SERVICE BULLETIN NO. SB-114-36

INSPECTION OF MAIN LANDING GEAR BRAKE TORQUE PLATE ASSEMBLY BOLT INSTALLATION

MODELS AFFECTED: Model 114, S/N 14000 thru 14442; Model 114A, S/N 14500 thru 14540;
Model 114B, S/N 14541 thru 14666; Model 114TC, S/N 20001 thru 20038

Figure 1

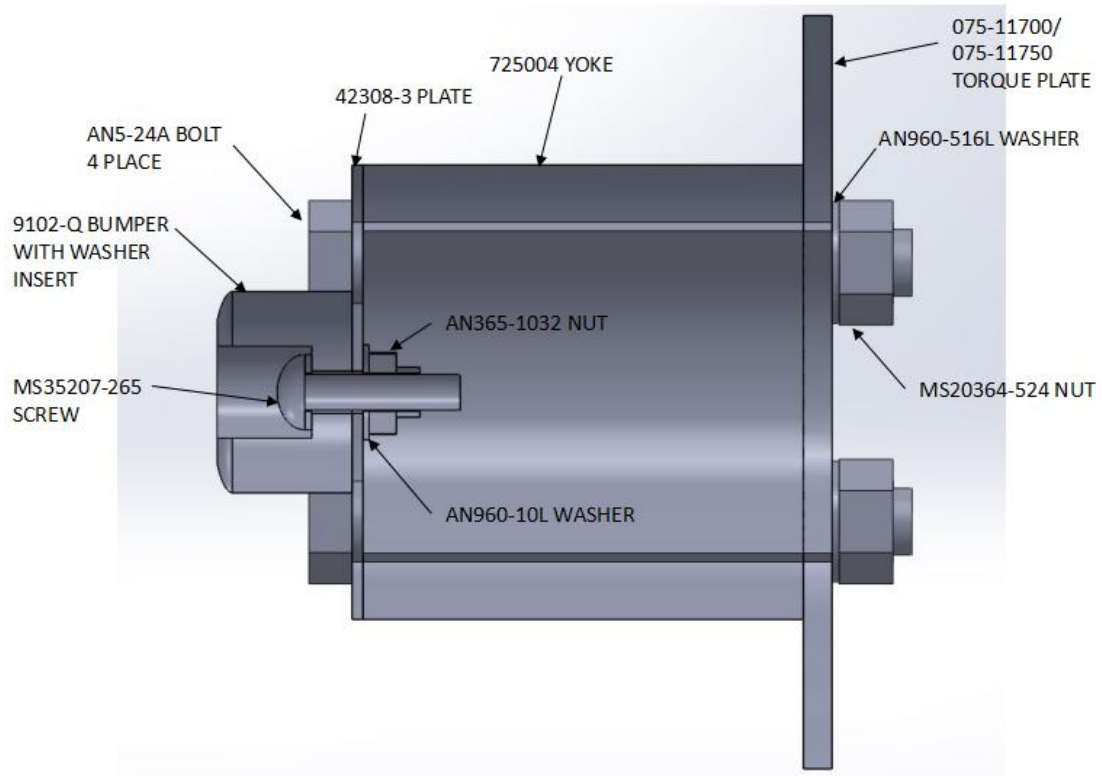
1. Inspect the four bolts which attach the main landing gear brake torque plate assembly to the main landing gear yoke.

Determine that the AN5-24A bolts(4) are installed with the bolt heads on the inboard side of the Main Landing Gear yoke, common to the 42308-3 Plate(Refer to figure 1). Using an inspection mirror, determine

that AN960-516L washers and MS20364-524 nuts are installed with a minimum of 1 thread through the nut. If minimum thread protrusion is showing, no further change is required.

2.If minimum thread protrusion is not showing, proceed to Part II.

Figure 2

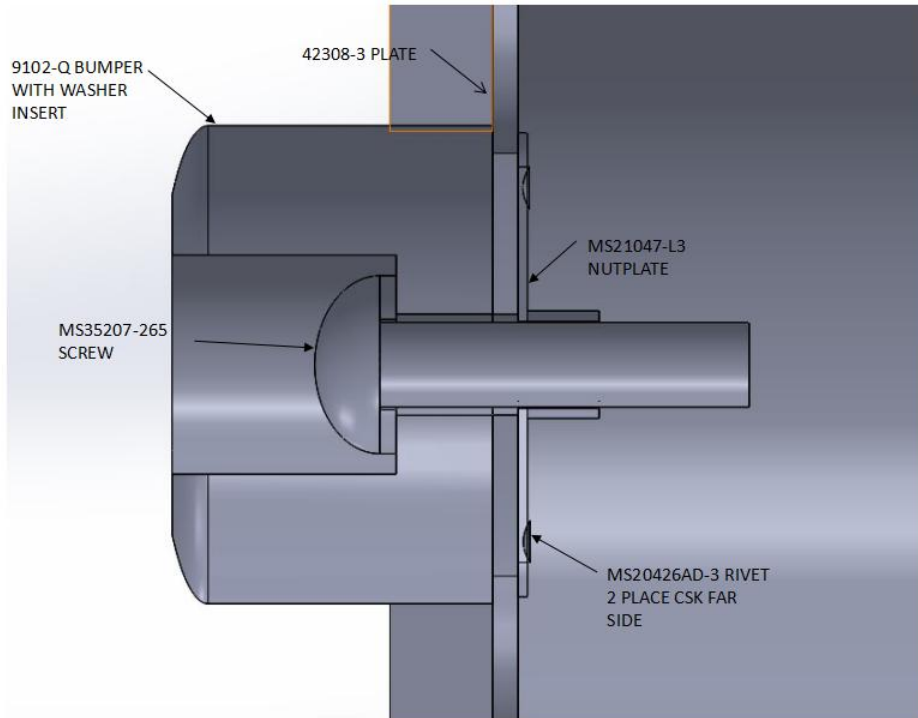
3. If required, replace the 9102-Q Bumper. To ease replacement of the 9102-Q Bumper, or equivalent 65+/-5 SDH Neoprene rubber bumper, it is recommended that the 42308-3 Plate be modified to 42308-501 Plate Assembly by installing a MS21047-L3 nutplate (Refer to figure 2). The 42308-501 Plate Assembly is common to late production Model 114B/114TC aircraft and is allowable for all spares.
